REV 4
E009-169

BECHTEL REVISION (DCP #43)

VENDOR'S DRAWING REVIEW

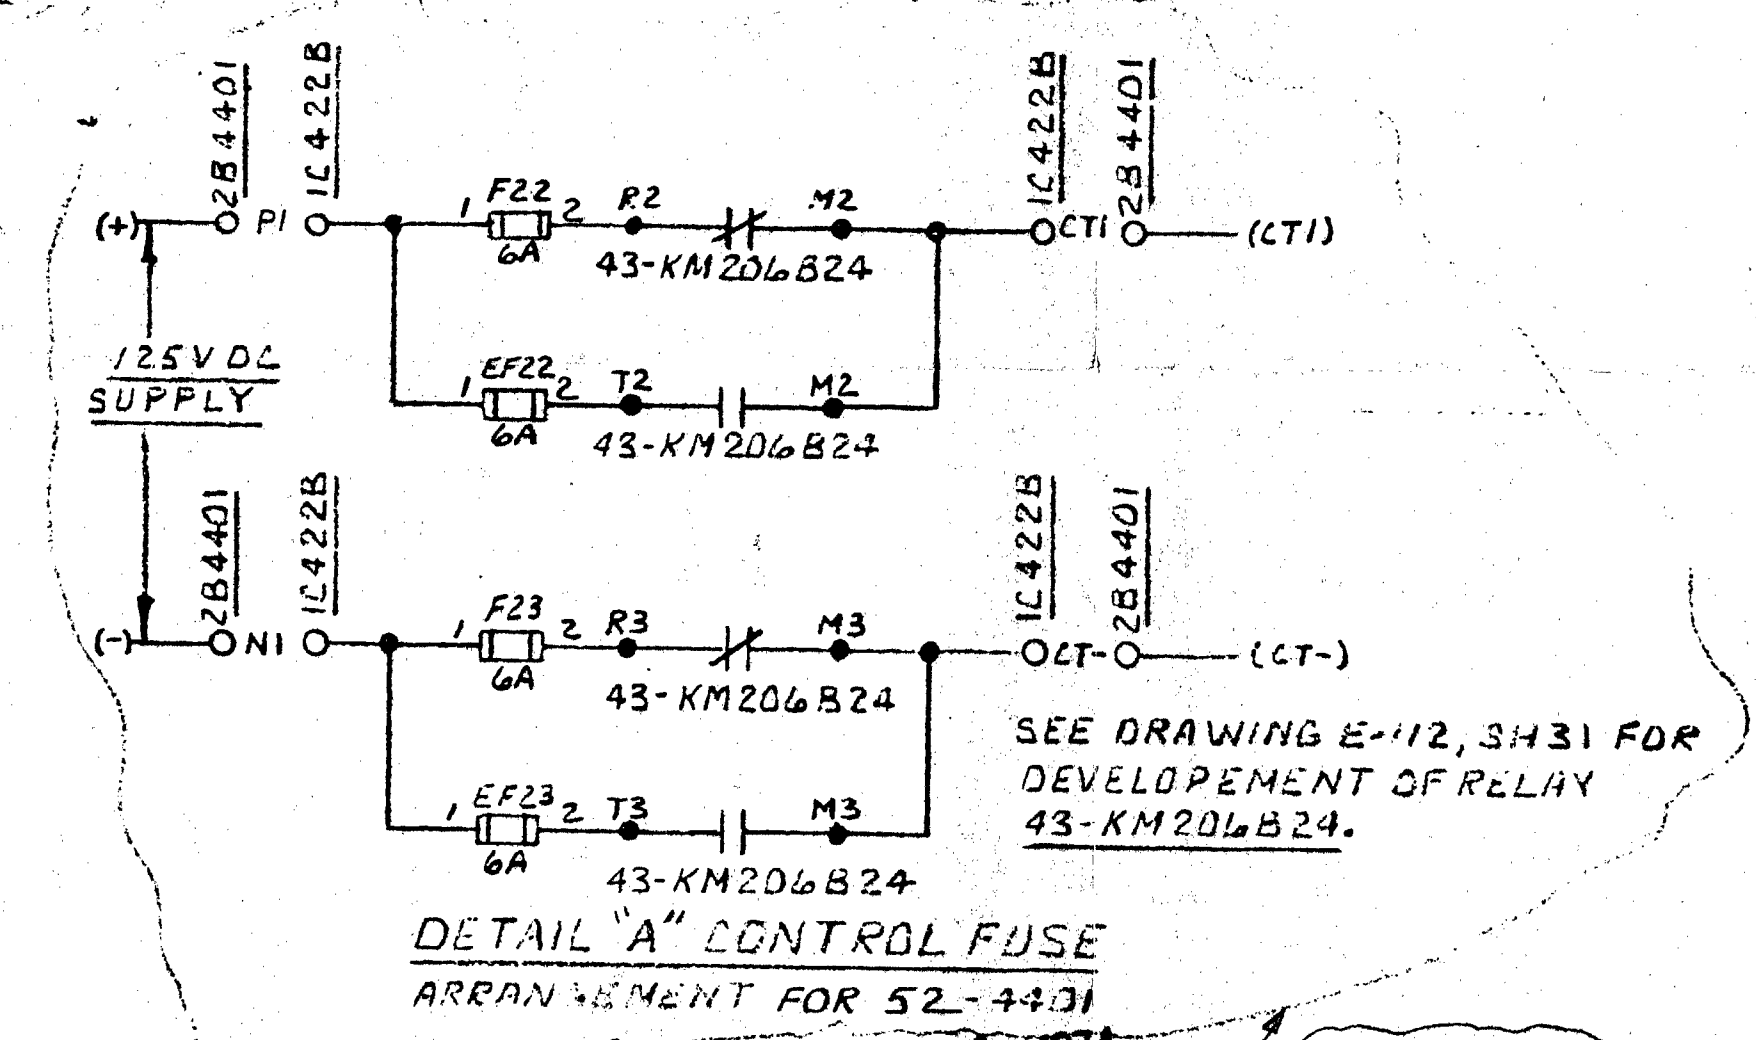
DCP CLOSURE NOTE: THIS DRAWING HAS BEEN REVISED TO SHOW DCP 1430 CHANGES. IT WILL BE SUPERSEDED BY A NEW VENDOR DUE AT DCP CLOSURE. ITEMS IDENTIFIED BY "SEE CLOSURE NOTE" SHALL BE TRANSFERRED TO THE NEW DUE AT DCP CLOSURE.
